Access Compliance Report

Public Rights-of-Way

(Pedestrian Signals)

Intersection ID: N/A	Main Street:	Cross Street: N/A	Location: N/A
ADA ID: FC658269B0BC	Signal Type: One Push Button-APS	Overall Compliance: No	Severity Score: BTN 1: N/A BTN 2: N/A No BTN: N/A
Codes/Mitigation Info/Possible Solution		Field Measurements/Component Compliance

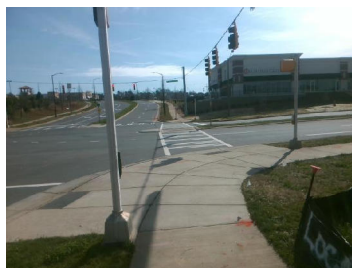
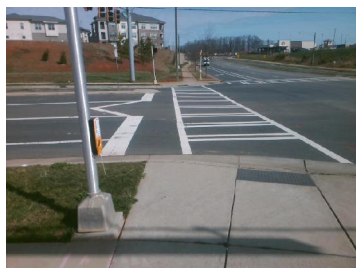
PROW/ADA: TMUTCD 4e.08, R404.2, R406.2, R209.1, MUTCD 4e.10

Yes	B 1 Clear Xing Direction?	ClearlyMarked	N/A	B 2 Clear Xing Direction?	N/A
	B 1 Crossing Direction	To N		B 2 Crossing Direction	N/A
Yes	B 1 DistanceTo XWalk (in)	41.0	N/A	B 2 DistanceTo XWalk (in)	N/A
No	B 1 DistanceTo Curb (in)	92.0	N/A	B 2 DistanceTo Curb (in)	N/A
Yes	B 1 Diameter (in)	2.0	N/A	B 2 Diameter (in)	N/A

Possible Solutions: Replace Signal Push Button With APS Button on New Post. Remove & Relocate Sign.
